Project	IEEE 802.16 Broadband Wireless Access Working Group < http://ieee802.org/16 >	
Title	DIUC/UIUC provision for supporting multiple advanced FEC types	
Date Submitted	2005-05-03	
Source(s)	Bin-Chul Ihm, Yongseok Jin, Kiseon Ryu, Changjae Lee and JinYoung Chun LG Electronics, Inc.	Voice: 82-31-450-7187 Fax: 82-31-450-7912 bcihm@lge.com
Re:	This is a response to a Call for Comments on IEEE P802.16e-D7	
Abstract	Provision of more DIUC rooms for supporting the multiple advanced FEC types. Revised text is pink.	
Purpose	This document is submitted for review by 802.16e Working Group members	
Notice	This document has been prepared to assist IEEE 802.16. It is offered as a basis for discussion and is not binding on the contributing individual(s) or organization(s). The material in this document is subject to change in form and content after further study. The contributor(s) reserve(s) the right to add, amend or withdraw material contained herein.

DIUC/UIUC provision for supporting multiple advanced FEC types

Bin-Chul Ihm, Yongseok Jin, Kiseon Ryu, Changjae Lee and Jinyoung Chun
LG Electronics

Figure 2. Proposed scheme for providing enough MCS levels i.e., DIUC/UIUC's for each FEC type

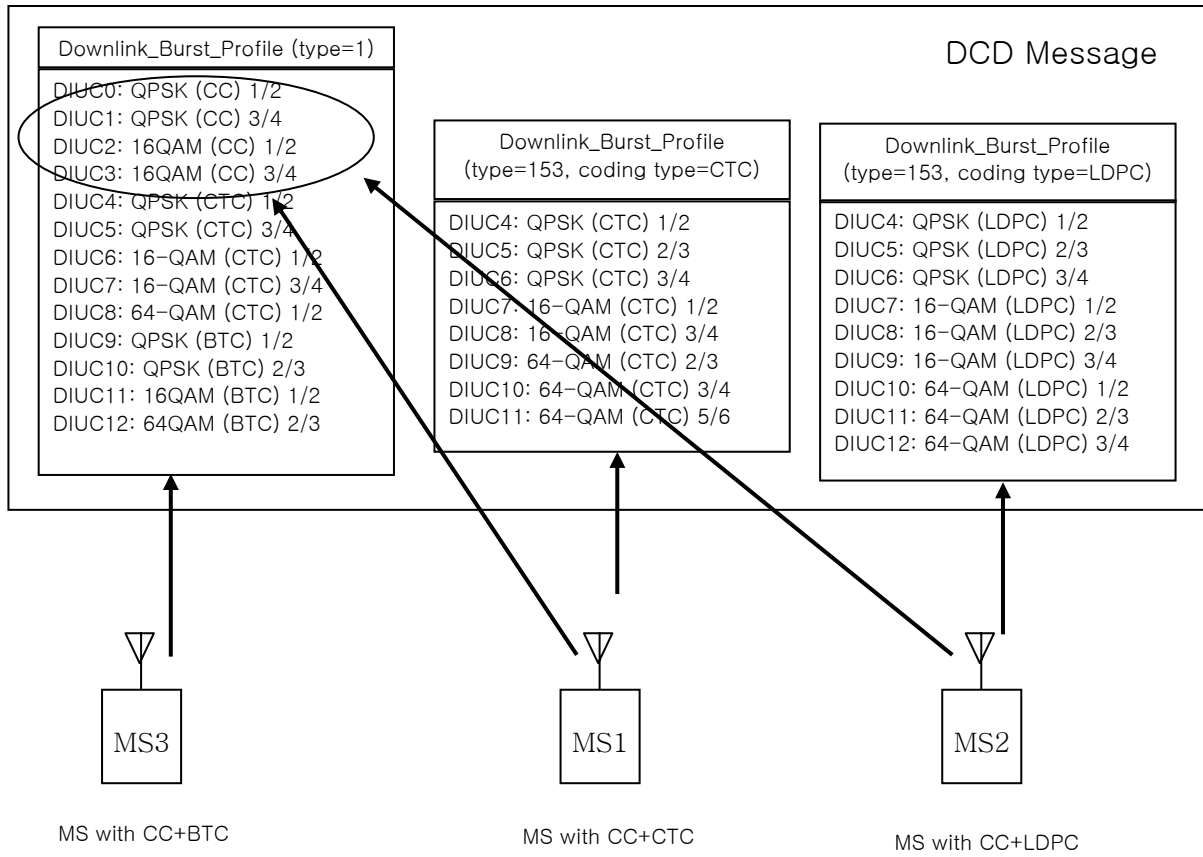
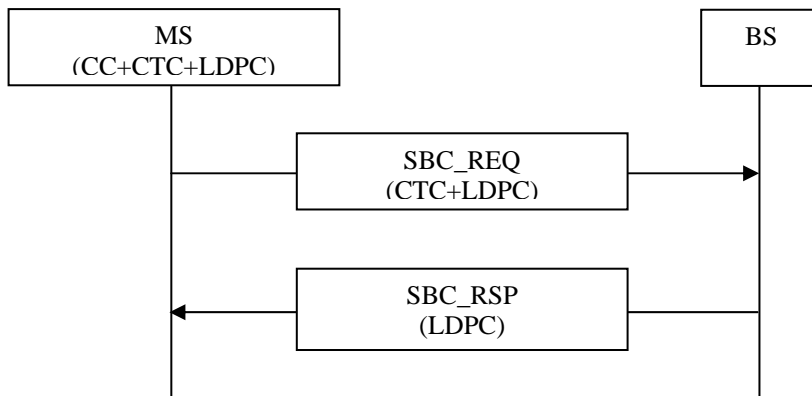
To provide more rooms for DIUC(UIUC) per each FEC type, we propose the extended DIUC(UIUC) which are dedicated to each FEC type as shown in Figure 2. 802.16-2004 version MS refers its DIUC(UIUC) set from downlink(uplink)_burst_profile and the later version MS can refer its DIUC(UIUC) set from each extended downlink(uplink)_burst_profile and downlink(uplink)_burst_profile for CC. In Figure 2, DIUC10 can be interpreted as one of three meanings of QPSK (BTC) 2/3, 64-QAM (CTC) 3/4 or 64-QAM (LDPC) 1/2 according to FEC type of MS. When there is no extended downlink(uplink)_burst_profile, the later version MS shall refer its DIUC(UIUC) set from the current downlink(uplink)_burst_profile.
